6 May 2022

Our Ref: R/2021/6/A  
File No: 2022/229540  
Your Ref: SSI-22765520

**Advice on EIS  
Sydney Metro West Stage 3 – Rail infrastructure, stations, precincts and operations**

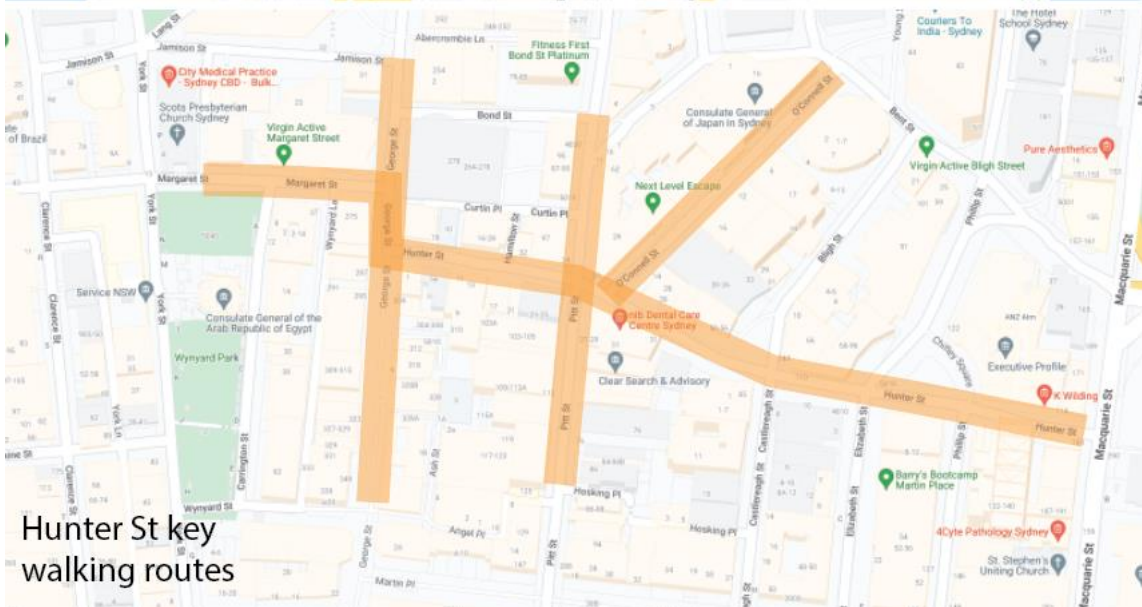
The red line boundary demarcates the limits of the project within which the proponent is responsible for all works to mitigate impacts. The official red line boundary has not been made public.

**We are concerned that the red line will be drawn (a) too narrowly and (b) in a way that arbitrarily cuts streets and hinders holistic precinct planning.**

**That TfNSW / Metro mitigate impacts on key walking routes for the metro stations as shown in figure above and that Metro work with the City to determine actions that are needed within the red line boundary as per Recommendations 3 and 4.**

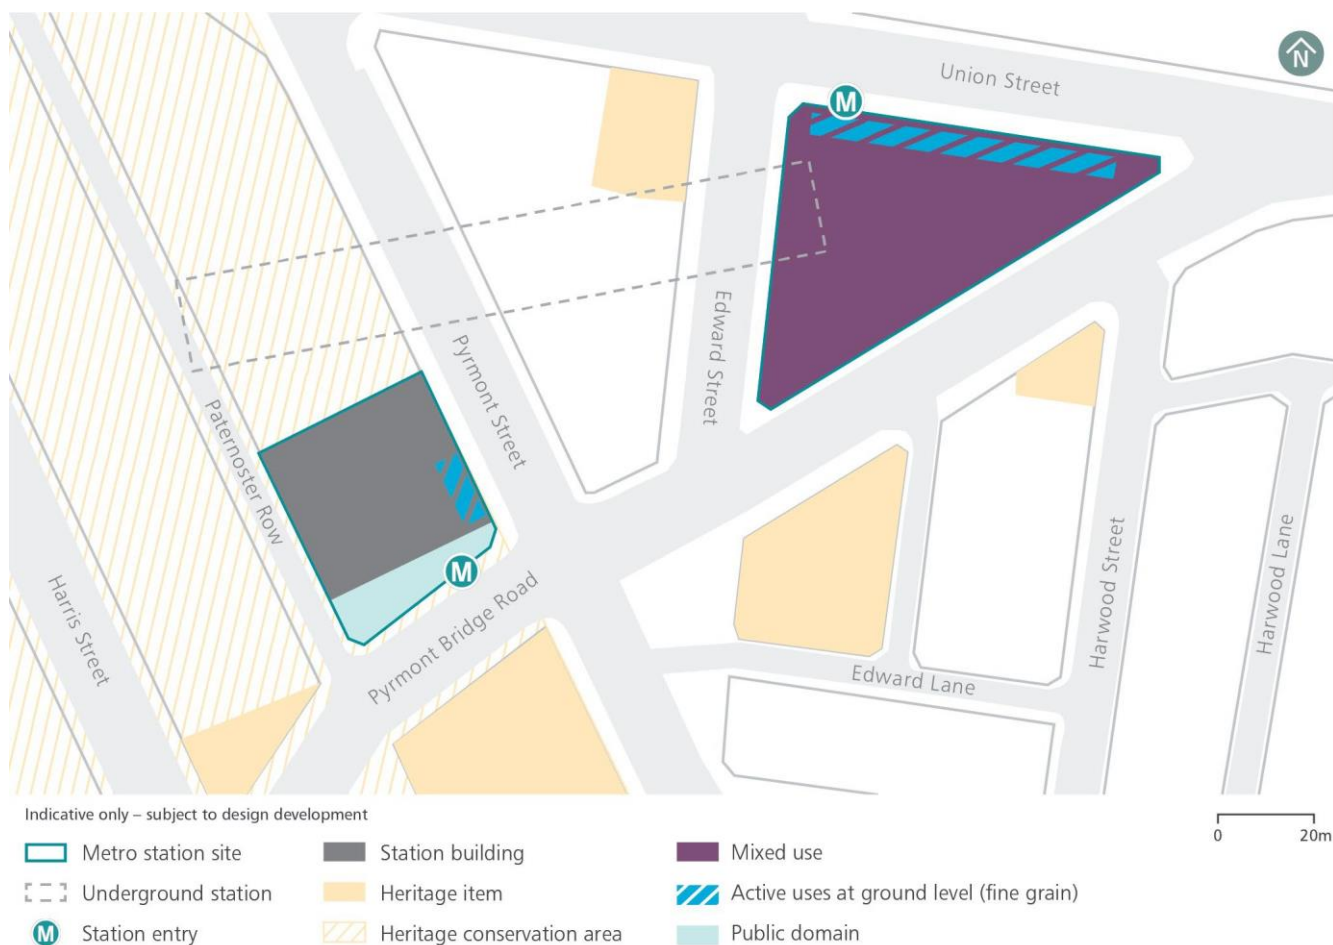
- Set back the eastern station building along Pyrmont Bridge Road to accommodate a safe and comfortable walking environment.  
**Extend the northern footpath in Pyrmont Bridge Road between the station and the Blackwattle Bay State Significant Precinct to provide a safe and comfortable walking environment.**

Hunter Street (Sydney CBD) Station places and spaces.

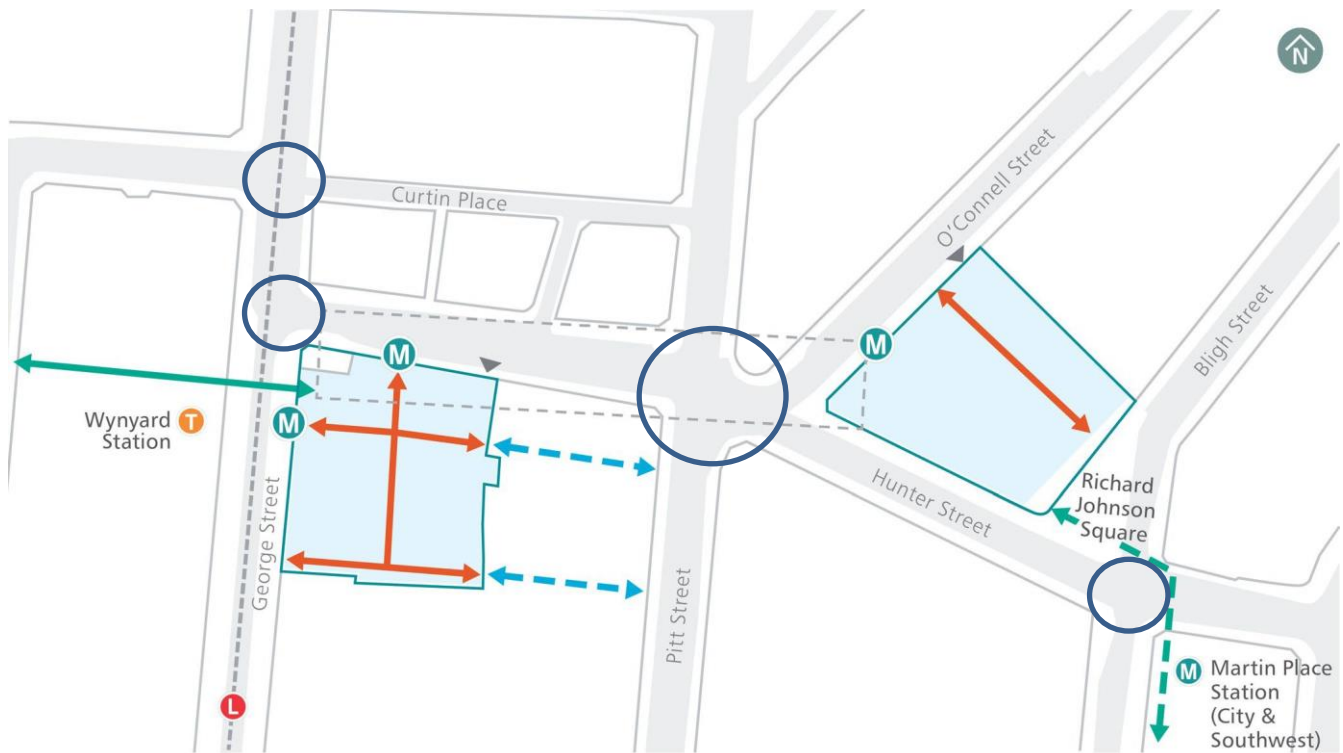
- set the **entire building above ground** back from Bligh Street to align with the adjoining heritage building (Lowy Institute Building) to **expand Richard Johnson Square (shown mauve in the diagram opposite)**, celebrate this heritage façade and promote a visual connection to Richard Johnson Square.
- **Sensitively Seamlessly** integrate **the setback area with** Richard Johnson Square **and** into the ground plane of the station precinct.
- **For the podium, build to the street alignments of O’Connell and Hunter Streets**
- Establish a legible station address at O’Connell Street, with a design which responds to its important CBD location.

- Integrate a through site link between Bligh and O’Connell Streets, to connect with the station entry and scaled to support activation ~~where possible.~~
